# DISCRETIONARY REVIEW ANALYSIS

**Record No.:** 2020-002743DRP-02  
**Project Address:** 1555 Oak Street  
**Permit Applications:** 2020.0226.5525 & 2020.0923.4827  
**Zoning:** RM-2 [Residential Mixed, Moderate Density]  
40-X Height and Bulk District  
**Block/Lot:** 1222 / 028A  
**Project Sponsor:** Charles Perry  
Charles Perry Associates  
231 41<sup>st</sup> Avenue  
San Mateo, CA 94403  
**Staff Contact:** David Winslow – (628) 652-7335  
[david.winslow@sfgov.org](mailto:david.winslow@sfgov.org)

**Recommendation:** Take DR and Approve with Conditions

**A0.1**

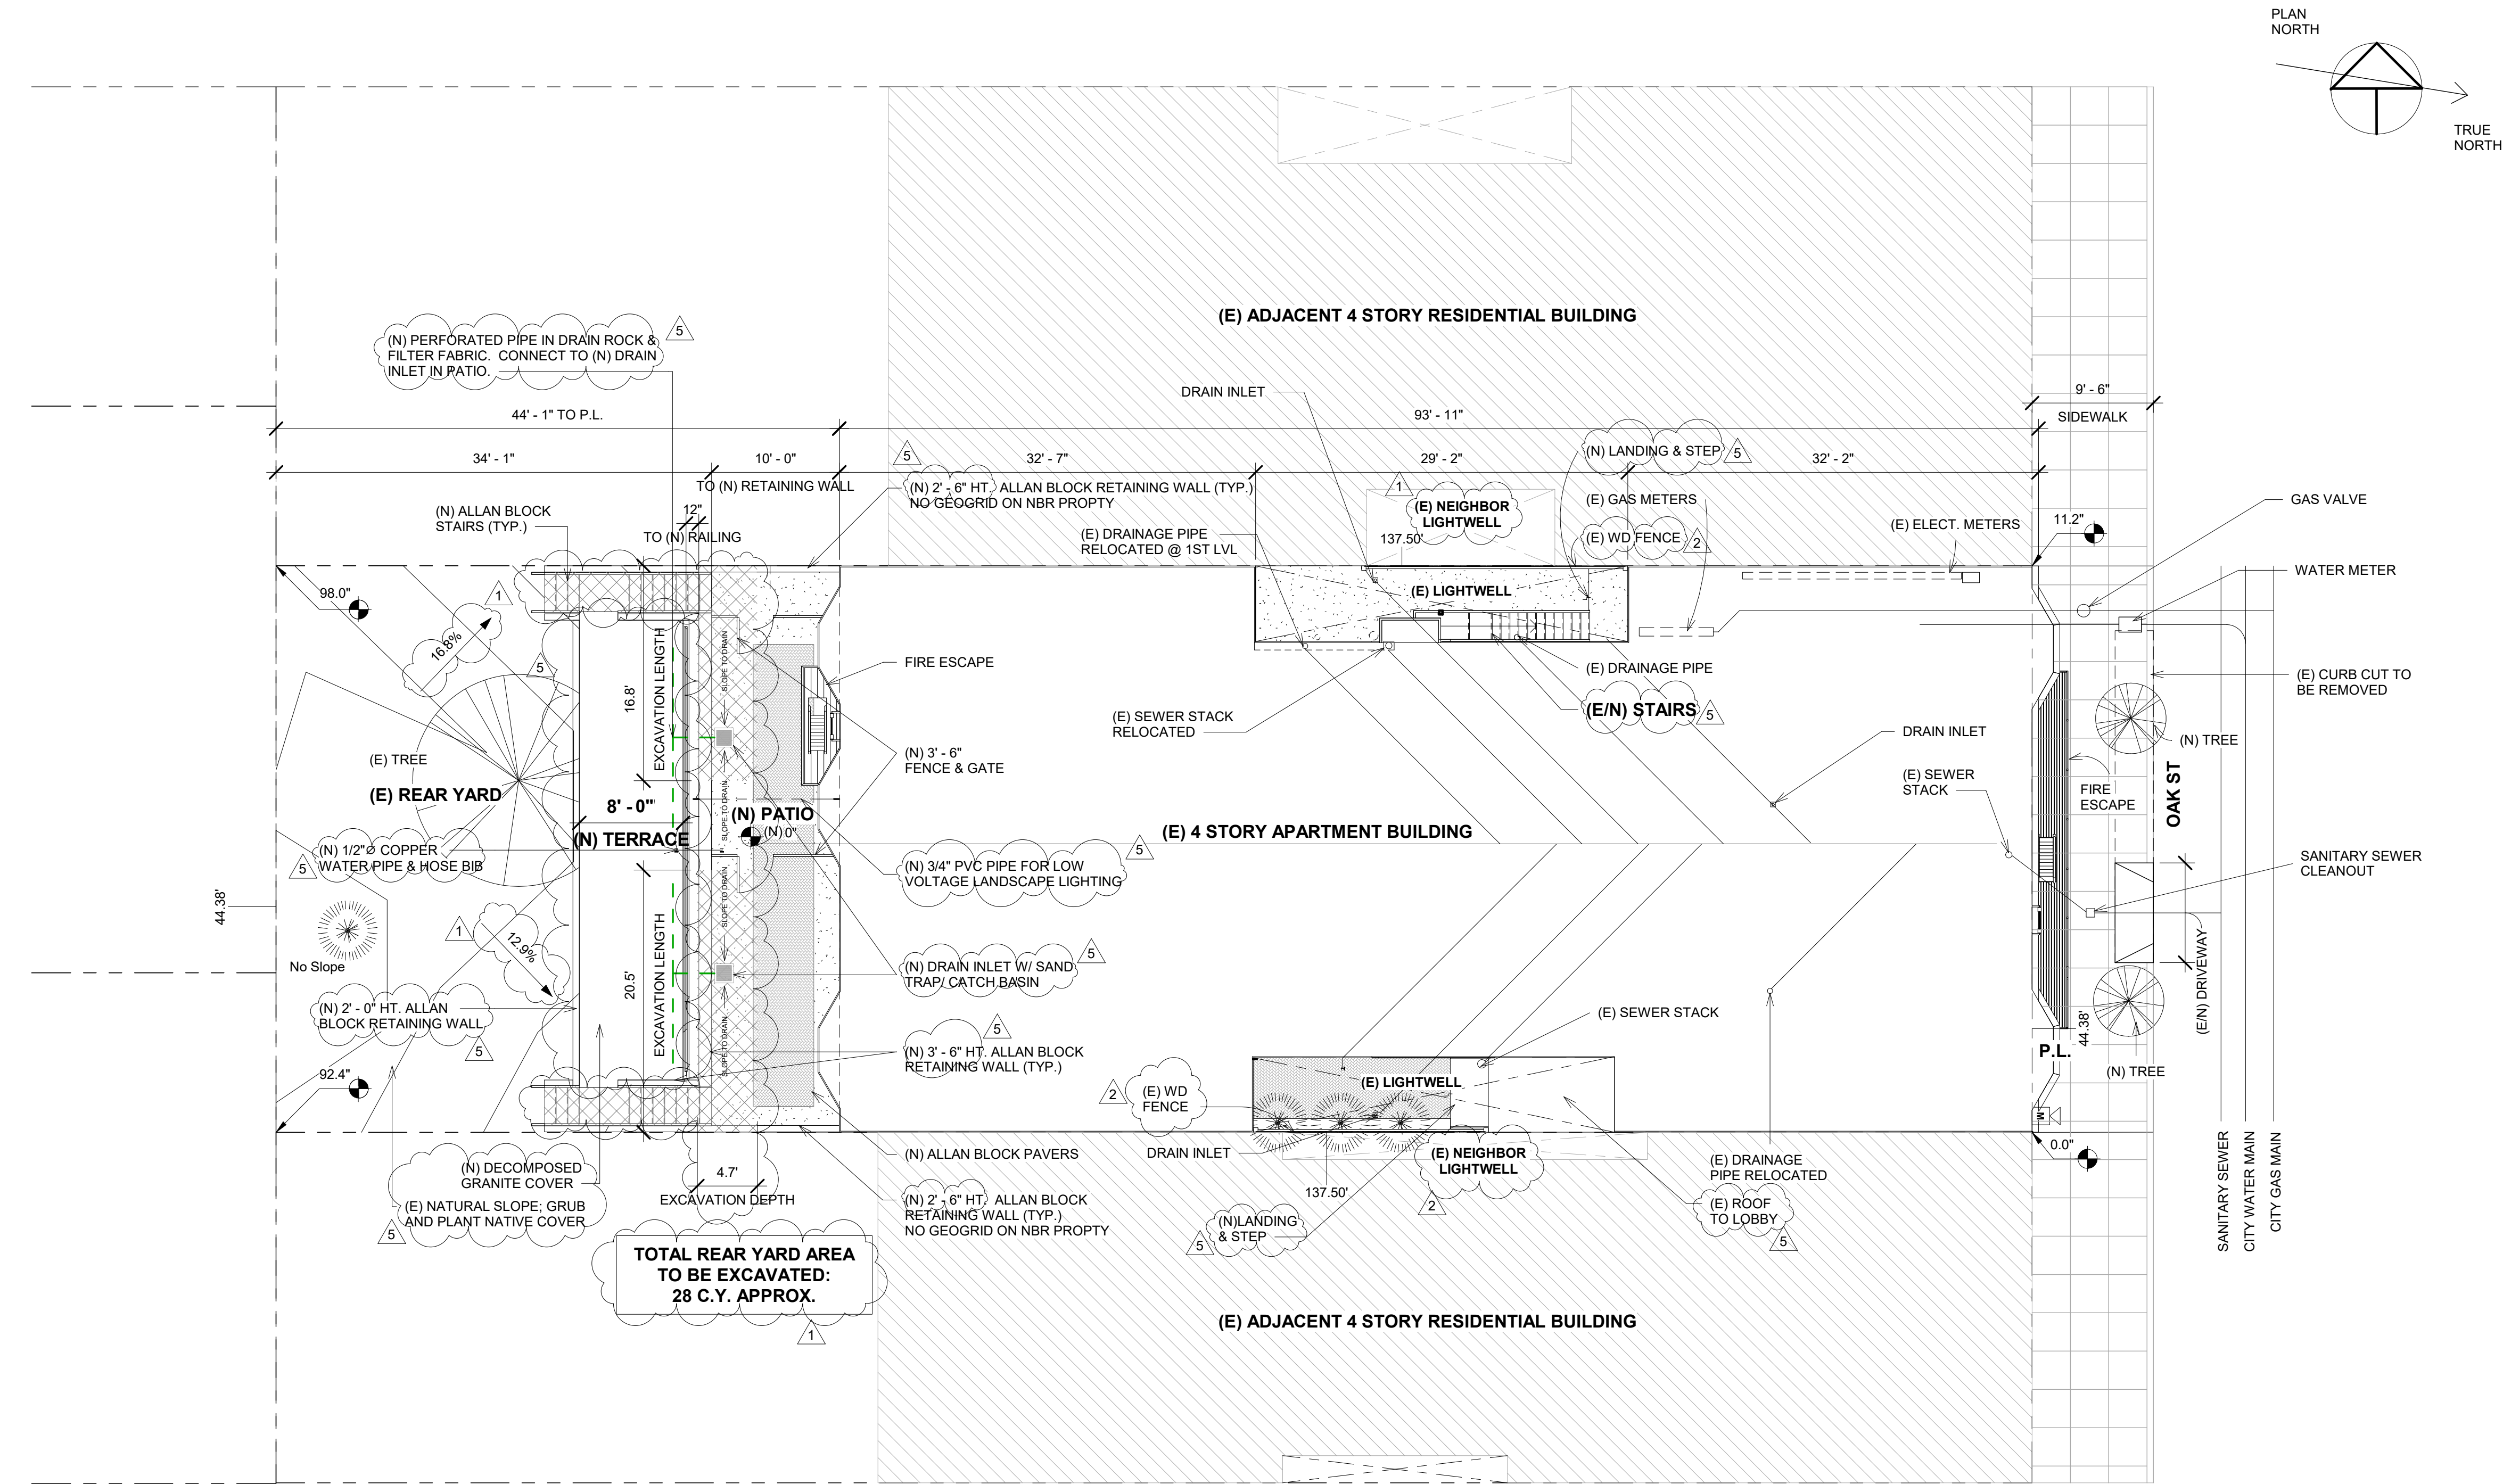
1. Detail 1, sheet A0.1;
  - a. Revision 5 shows, as a green dashed line, the “perforated pipe in drain rock and filter fabric”. Please identify the diameter of the perforated pipe, and the dimension of the drain rock and filter fabric, and whether it will interfere with the geogrid placement behind the wall. Also, please show in the plan view the perforated pipe in drain rock and filter fabric along the 2’ retaining wall, as indicated in Detail 2 and the overall plan on sheet A6.1. Detail 2 may be a good place to show the extent of the filter fabric and drain rock.

**A6.1**

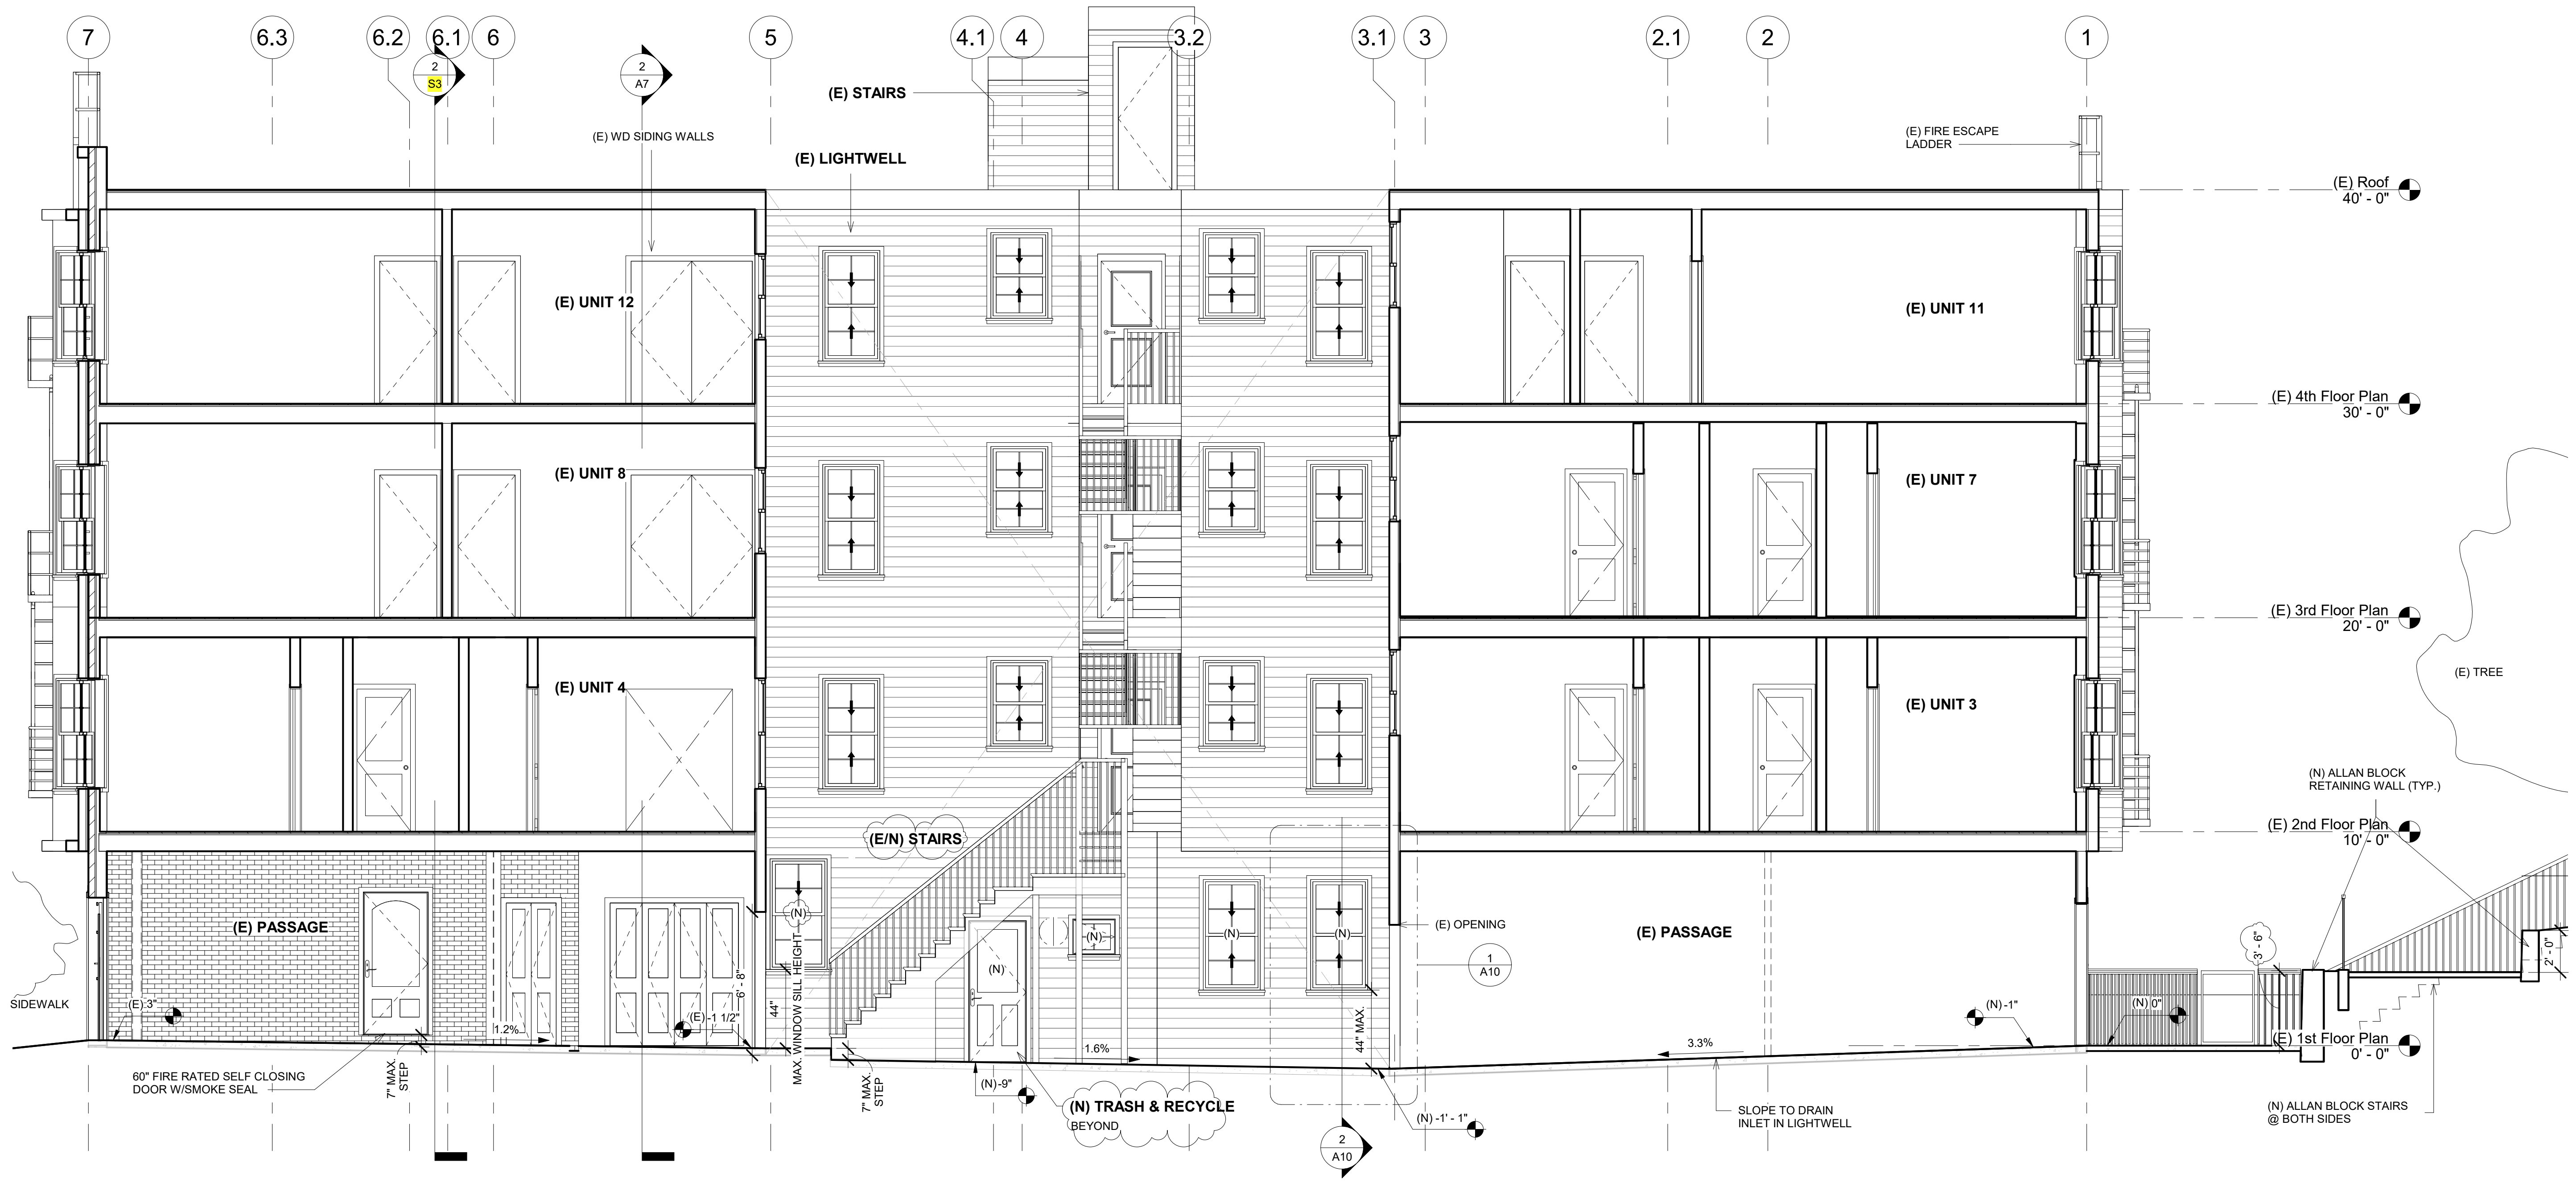
- b. Revision 5 also notes that this wall will not have geogrid on the neighboring property, which would be required per Detail 2, Sheet A6.1. As the Allan Block retaining wall appears to rely upon the geogrid for stability, please explain how this wall will be adequate and stable to protect the adjacent property without the geogrid. It appears a vertical reinforced retaining wall may be required in this location. Also, please confirm the length of this wall along the property line.

3. Detail 2, sheet A6.1;
  - a. Please confirm that the symbol just left of the Allan Block Units represents Well-Graded Granular Wall Rock per the typical Allan Block design.
